NR:IBO-01/034

SUBJECT: SUBMITTAL OF RECOMMENDED COURSE OF ACTION FOR S1W LEACHING BEDS CAPACITY

S1W Leaching Beds Capacity Issues

Figure 1 Recommended Placement of SSCs

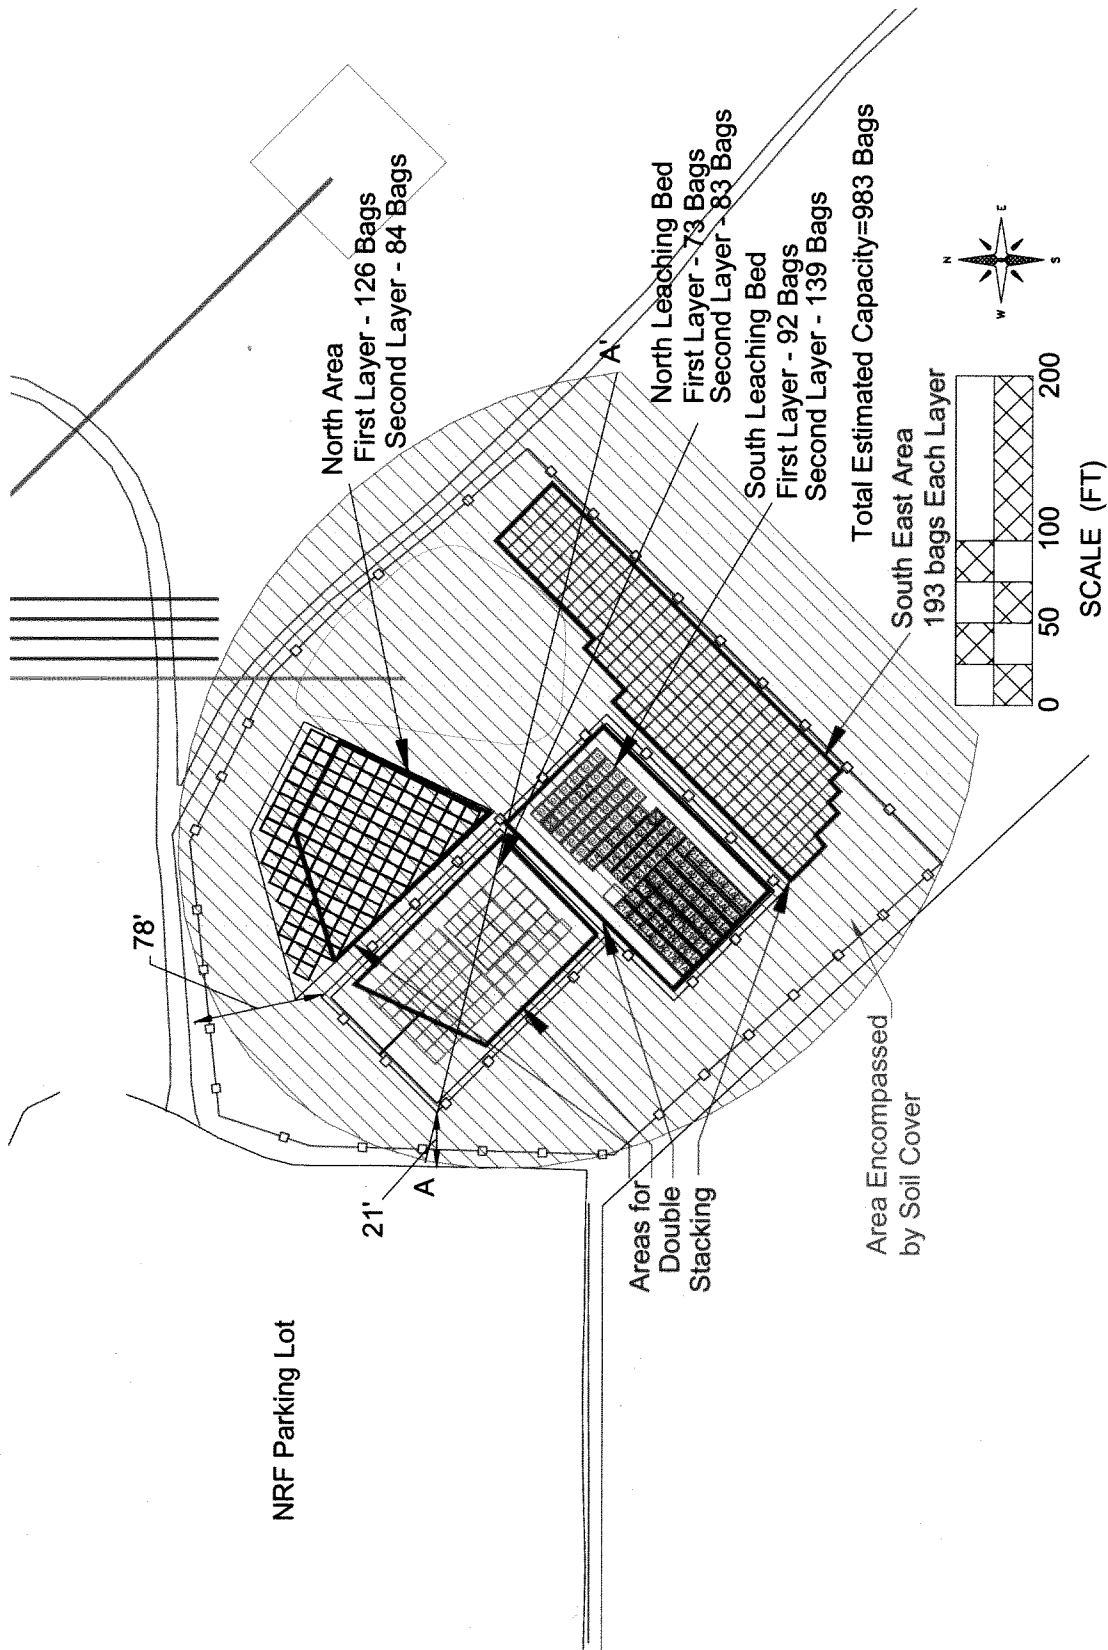
Because of the anticipated additional number of SSCs, the actions required to handle the additional SSCs must be addressed. The recommended action, shown on Figure 1, includes placing SSCs outside the leaching beds, but within the existing contamination zone. The area outside the beds would need to be grubbed (vegetation removed) and prepared for the SSCs. In addition, a foot or two of surface soil could be removed in the locations outside the beds where the SSCs are to be placed. This soil could be placed around the SSCs in the leaching beds where void spaces currently exist. The removal of this soil would serve several purposes, as follows:

A double layer of SSCs would be placed within and adjacent to the leaching beds. The double layer of SSCs would be placed in strategic locations within the S1W Leaching Beds. Since the leaching beds have tapered sides, it is estimated that another row of SSCs can be placed around the perimeter when the second layer of SSCs is placed in the leaching beds. This would allow the second layer to have significantly more capacity in the leaching bed area than the first layer at the bottom of the beds. For example, in the south leaching bed the first layer contains 92 SSCs, but the second layer (including the additional row of SSCs around the perimeter) would potentially contain 139 SSCs. Portions of the north bed will contain only a single layer, to prevent encroachment of the engineered cover on the NRF parking lot and perimeter road.

The area outside the leaching beds where SSCs could be placed would be encompassed by the proposed engineered cover over the leaching beds (NRF-14) and leaching pit (NRF-12B), and would be within the currently fenced area. The cover would encompass these areas for several reasons: (1) ease of cover design, construction, and placement; (2) necessity to encompass the contaminated zone below the surface in proximity to NRF-12B and NRF-14; and (3) requirement to cover isolated contaminated near-surface areas between NRF-12B and NRF-14. In addition, the areas outside the leaching beds have natural depressions (between the leaching beds and the leaching pit and to the southeast of the leaching beds), which lend themselves for the placement of SSCs. There is some uncertainty concerning the size of the leaching pit toward the southern end of the site, and whether it extended to the fence line surrounding the area. Past analytical data given in the NRF Comprehensive Remedial Investigation/Feasibility Study indicates the contamination below the surface could extend to the southeast fence line. Also, a topographical map shows a slightly raised area that extends from the asphalt cover at NRF-12B to the fence line, which would indicate the possible location of the extended portion of the pit that was later filled in.

The recommended action is shown in Figure 1 (with a cross-section view shown in Figure 2). This would have a minimal affect on the design of the proposed cover. SSCs on the second layer would be strategically placed such that the perimeter dirt road would not be impacted.

The recommended action should accommodate the volume of contaminated soil expected from the remedial actions, preventing the need to ship soil off-site. Approximately 983 SSCs could be accommodated using this option, which provides a small margin over the new conservative soil volume estimates. The cover would have to be slightly larger in the southeast direction to attain the proper slope requirements, due to the higher cover elevation associated with a second layer of SSCs. Although the cover would be slightly larger than originally envisioned, the footprint of contaminated soil would not increase since the SSCs would be placed in areas with near-surface and subsurface contamination.

Figure 2 Cross-section from Figure 1

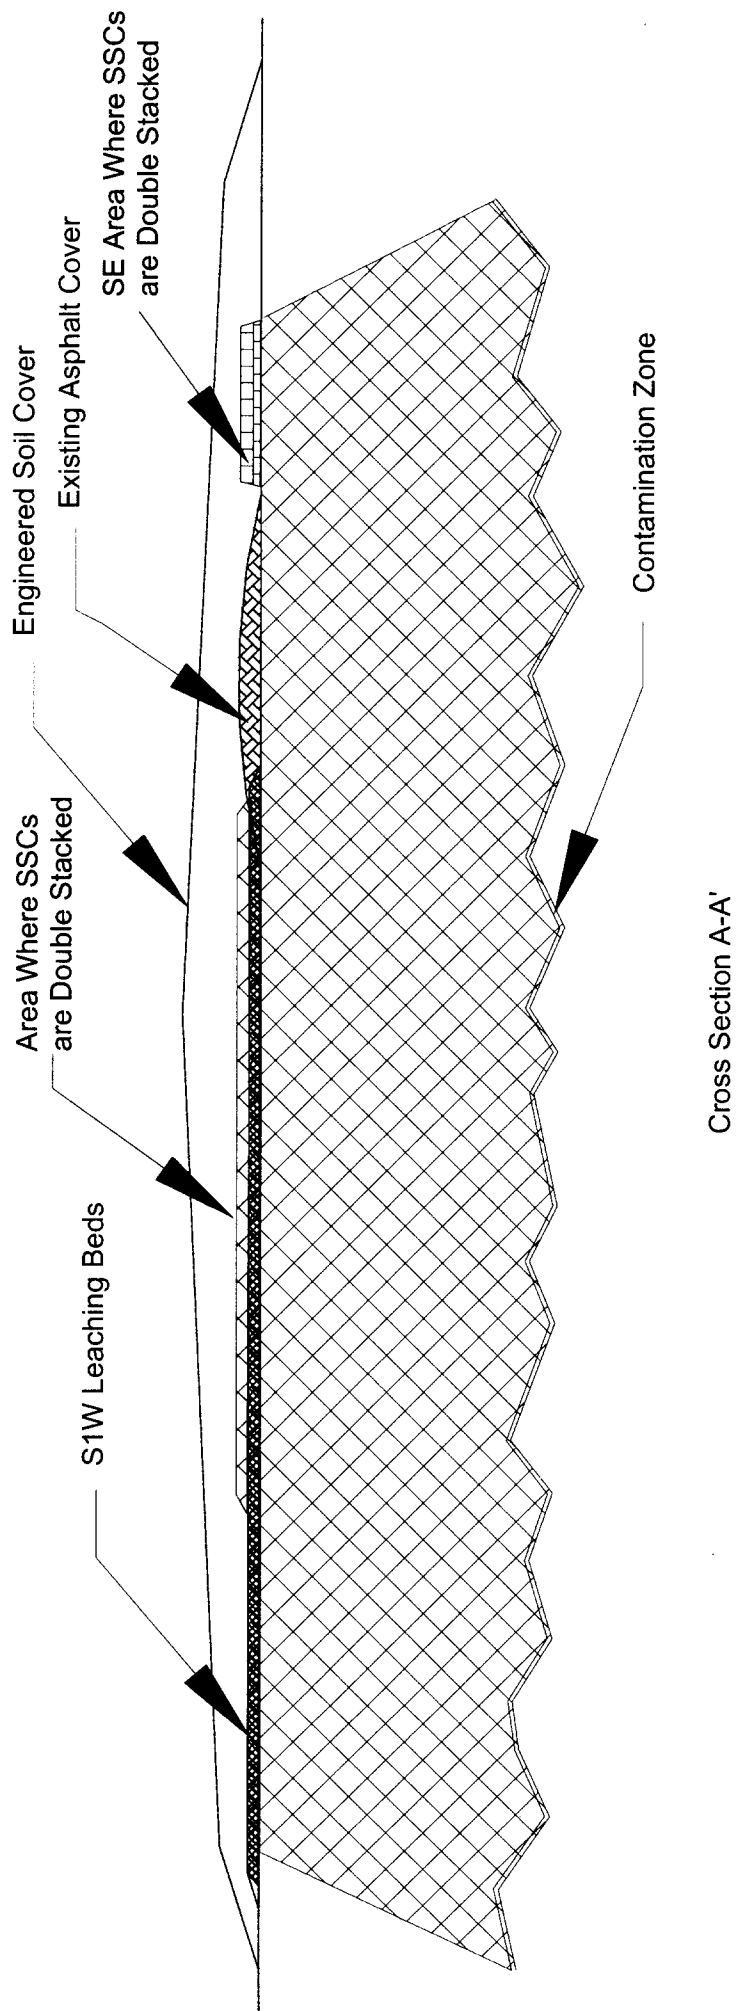
The Work Plan states that a 6-12 inch layer of soil would be placed between the two levels of SSCs. After discussions with the current subcontractor personnel who have experience with road construction and landfill operations, a soil layer of at least 18 inches is needed to provide the proper stability for heavy equipment to transport and place the SSCs for the second level. The reduced loading height of the SSCs will counteract the increased height due to this soil layer.

Figure 3 Original Proposal for SSC Placement given in the Phase I RD/RA Work Plan

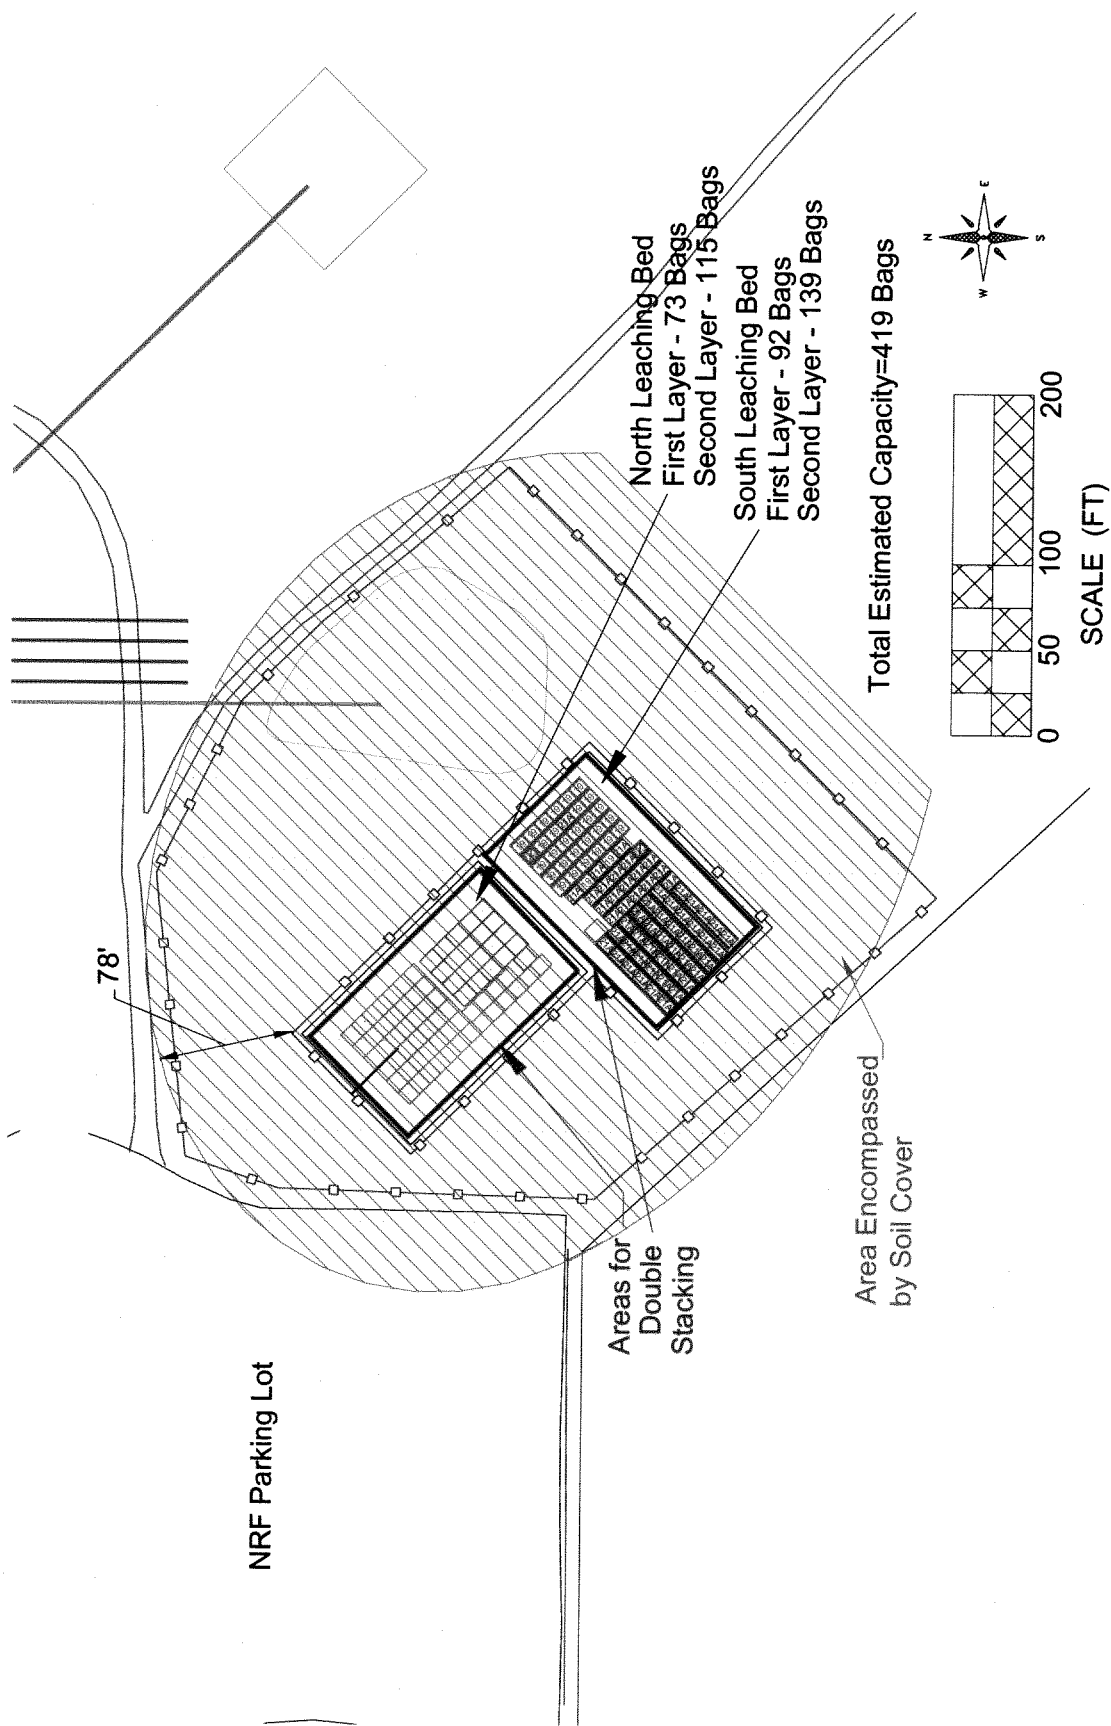
The option given in the Phase I RD/RA Work Plan showed a double layer only within the leaching beds. As can be seen from Figure 3, the original proposal identified in the Work Plan, the currently estimated soil from the remaining CERCLA remedial actions could not be accommodated within the original capacity. Absent an amended on-site soil plan, excess soil would have to be sent off-site for disposal at a proposed soil repository at the Idaho Nuclear Technology and Engineering Center (INTEC), the Radioactive Waste Management Complex (RWMC), or an off-INEEL facility such as Envirocare in Utah. In addition, shipment of SSCs off-site would require more sampling of the soil (for characterization purposes), would tend to retard the excavation work, and would incur additional costs for sampling, packaging, transportation, and disposal. The Feasibility Study estimated off-site disposal of soil at \$400 per cubic yard. Figure 3 shows that an estimated total of 419 SSCs could be placed in double layers within the leaching beds. This would require up to 472 SSCs (3500 cubic yards; \$1.4M) to be sent off-site if the higher soil volume estimates from Table 1 are encountered.
